USNRC APPLICATION
SUA-1341 License Amendment
Ludeman Project
Converse County, WY

June 2013

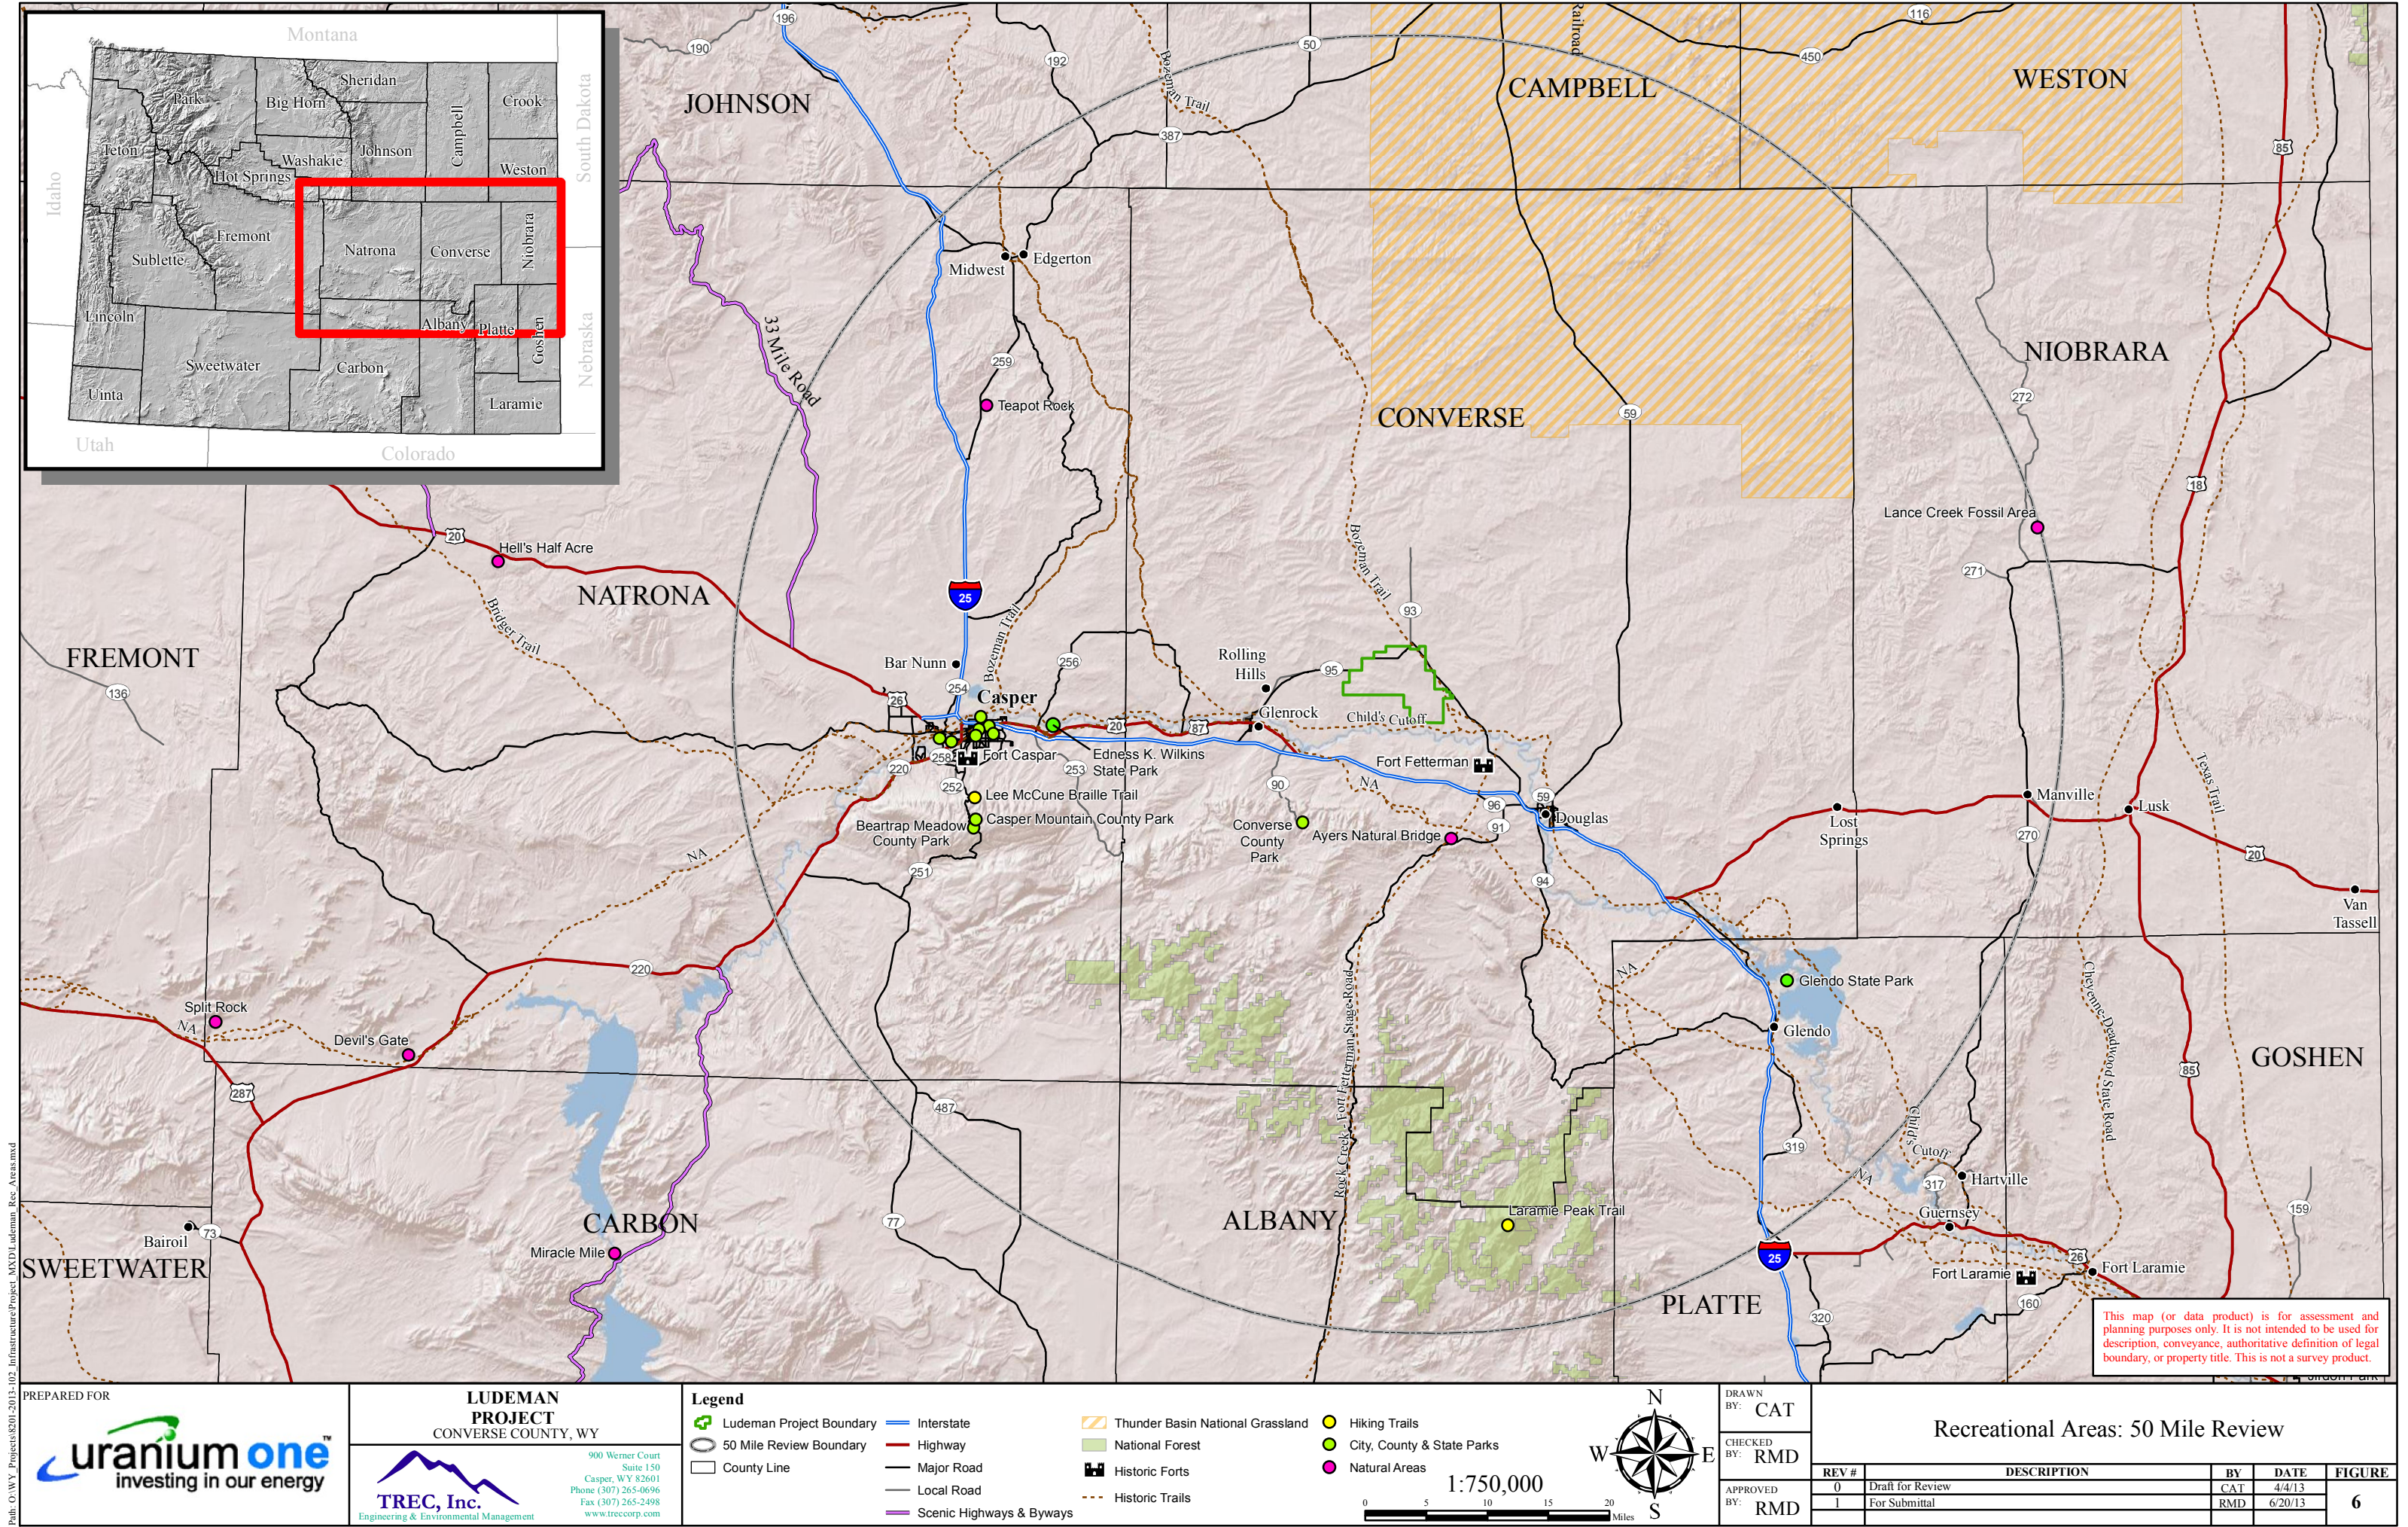
- A. Please provide a map showing the location of recreational areas and trails (e.g., the Child's Cutoff Trail) on the Ludeman Project and in the surrounding area.*
- B. Please specify whether hunting occurs on Federal or State lands within the Project boundaries.*
- C. Please discuss the impacts to recreational areas from the proposed Ludeman Project.*

To better facilitate the NRC's characterization of existing land uses and potential recreational impacts a map of recreational areas and trails in the vicinity of the proposed project will be inserted in ER Section 3 and is provided below.

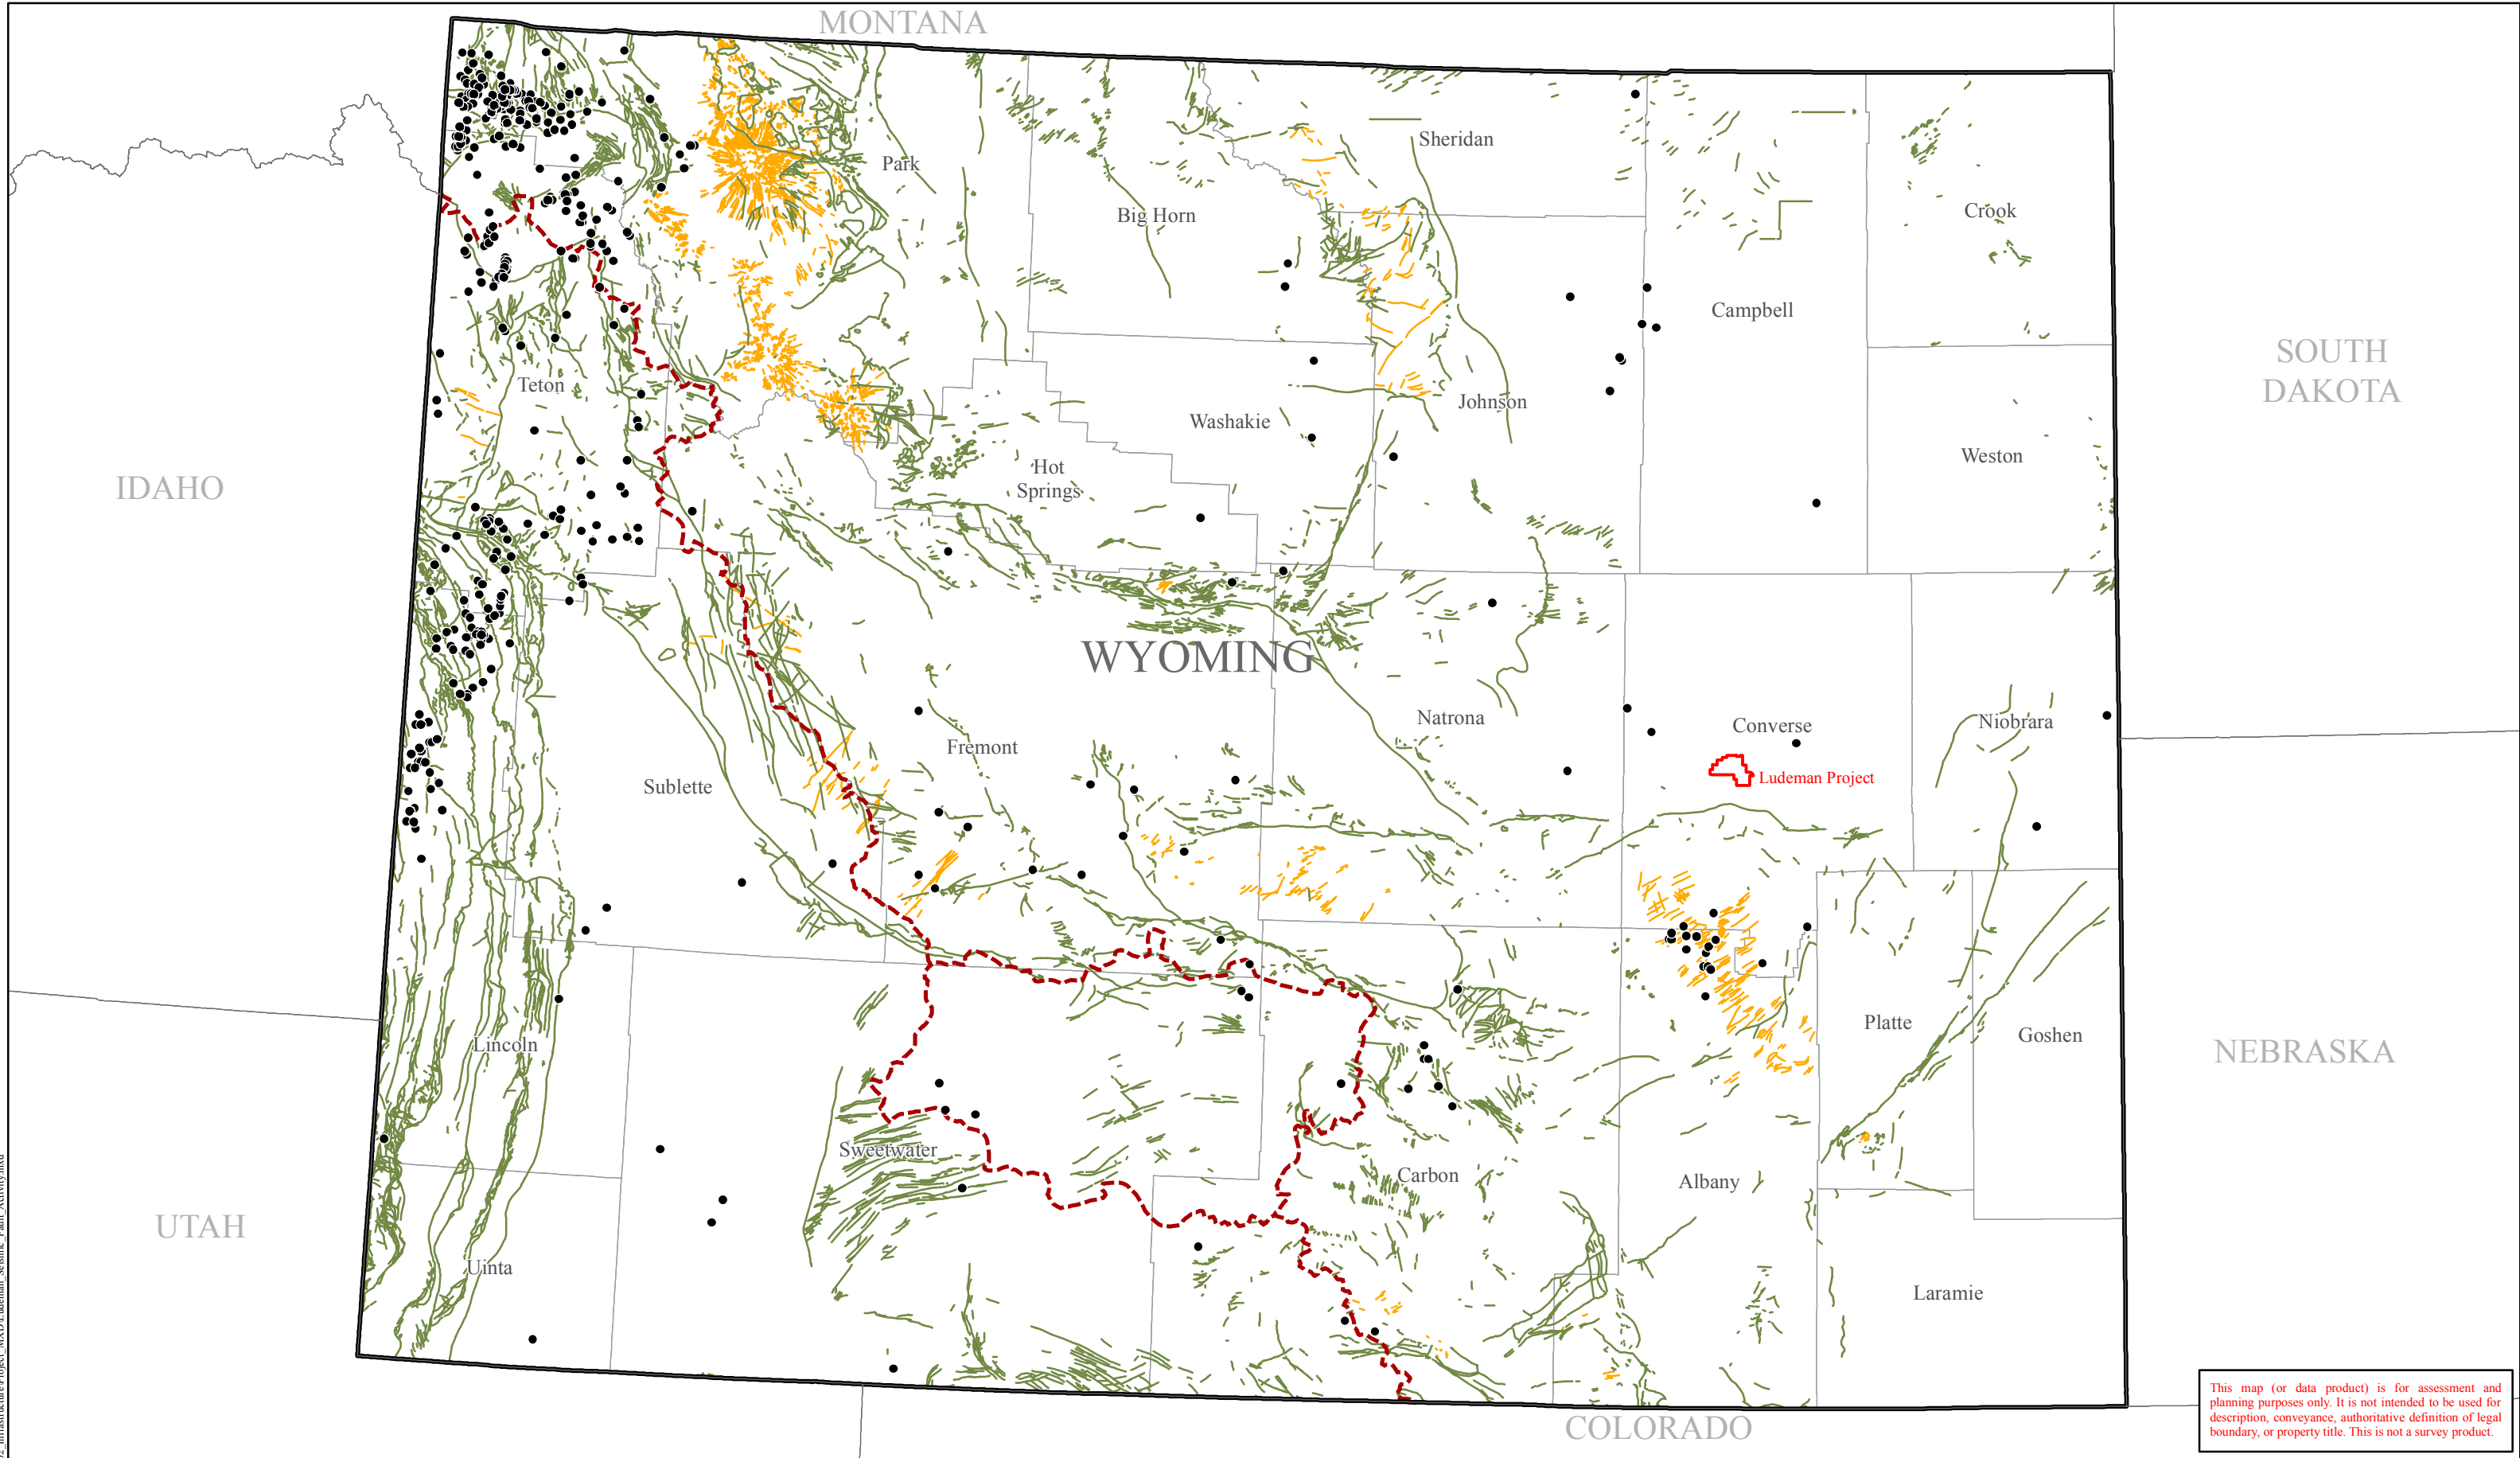
Please provide information on the potential for seismicity induced by the deep-well injection of waste water proposed for the Ludeman Project.

The figure below has been added to ER Section 3.3 to illustrate known faults in relation to the project area:
